Access Compliance Report Public Rights-of-Way (Island Curb Cuts)

Main Street: O_NEILL_DR		Cross Street: CROWN_VALLEY_PKWY		Location:	SW
ADA ID: CCRK211102122241	Curb Cut Type: IslandRefuge3	Initial Pass/Fail: Fail	Overall Compliance: No	Severity Score:	40
Codes/Mitigation Info/Possible Solution			Field Measurements/Component Compliance

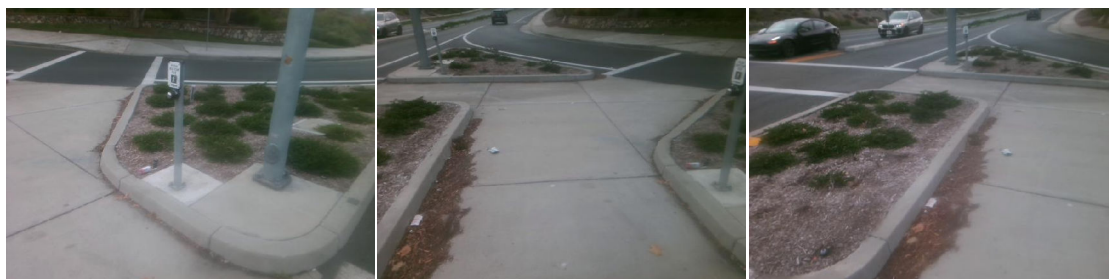
Remove & Replace Entire Refuge. Utility Present.
